Subject: Issuance of Amendment No. 75 to Facility Operating License NPF-9  
and Amendment No. 56 to Facility Operating License NPF-17 - McGuire  
Nuclear Station, Units 1 and 2 (TACs 65437/65438)

AMENDMENT NO. 75 TO FACILITY OPERATING LICENSE NPF-9 - McGuire Nuclear Station, Unit 1  
AMENDMENT NO. 56 TO FACILITY OPERATING LICENSE NPF-17 - McGuire Nuclear Station, Unit 2

SAFETY EVALUATION BY THE OFFICE OF NUCLEAR REACTOR REGULATION  
RELATED TO AMENDMENT NO. 75 TO FACILITY OPERATING LICENSE NPF-9  
AND AMENDMENT NO. 56 TO FACILITY OPERATING LICENSE NPF-17

FIGURE 5.1-3

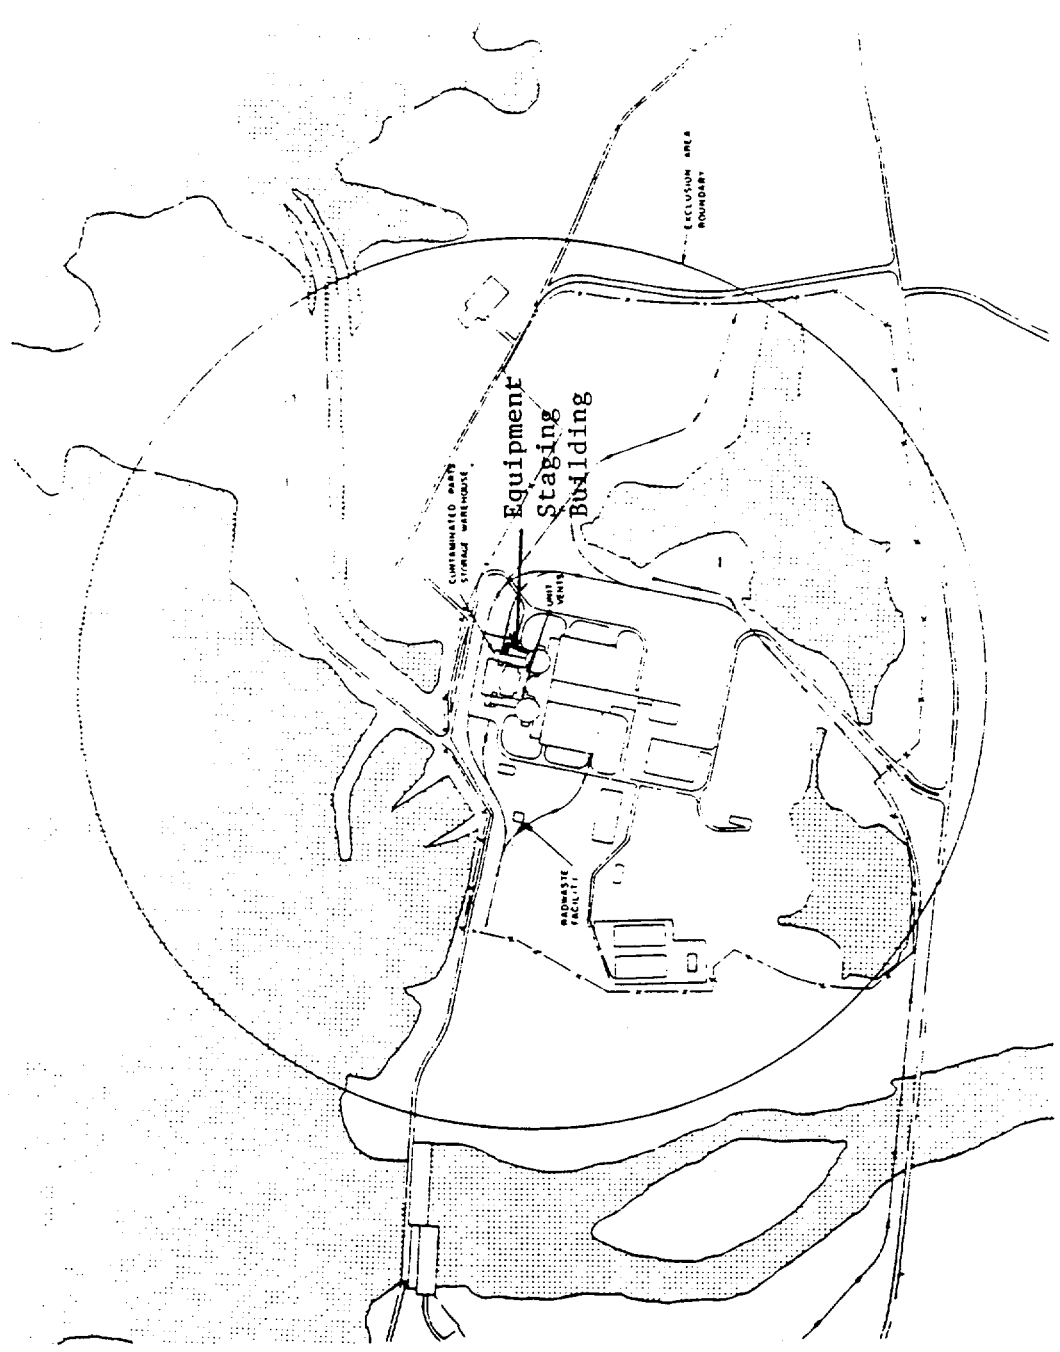
Specifically, TS Figure 5.1-3 "Site Boundary for Gaseous Effluents," which shows locations within the Exclusion Area Boundary for radioactive gaseous effluents released to unrestricted areas, would be revised to reflect the addition of the ESB. Changes to TS Table 3.3-13 "Radioactive Gaseous Effluent Monitoring Instrumentation" would add minimum channel operability requirements applicable during gaseous effluent releases, and associated actions required with the number of operable channels less than specified, for the noble gas activity monitor (EMF-59), flow rate monitor, and sampler minimum flow device of the ESB ventilation system. Similarly, changes to TS Table 4.3-9 "Effluent Monitoring Instrumentation Surveillance Requirements" would add surveillance requirements (channel check, source check, channel calibration frequency, and analog channel operational test frequency) for these same three monitors, applicable at all times except when the ventilation system isolation valve is closed and locked. TS Table 4.11-2 "Radioactive Gaseous Waste Sampling and Analysis Program" would be revised to reflect the addition of the ESB as new item 4c, and to reflect sampling and analysis requirements corresponding to those presently specified for the Radwaste Facility Vent (item 4a) and Contaminated Materials Warehouse (item 4b).

An additional change would correct inconsistent names for the same structure; the reference to "Contaminated Materials Warehouse" in TS Table 4.11-2 (item 4b) and to "Contaminated Parts Storage Warehouse" in Figure 5.1-3 would both be changed to "Contaminated Parts Warehouse."

The change to TS Table 4.11-2 (item 4b) and to TS Figure 5.1-3 to correct the name of the Contaminated Parts Warehouse is a purely administrative change to achieve consistency throughout the TS. It has no adverse safety implication and is, therefore, acceptable.
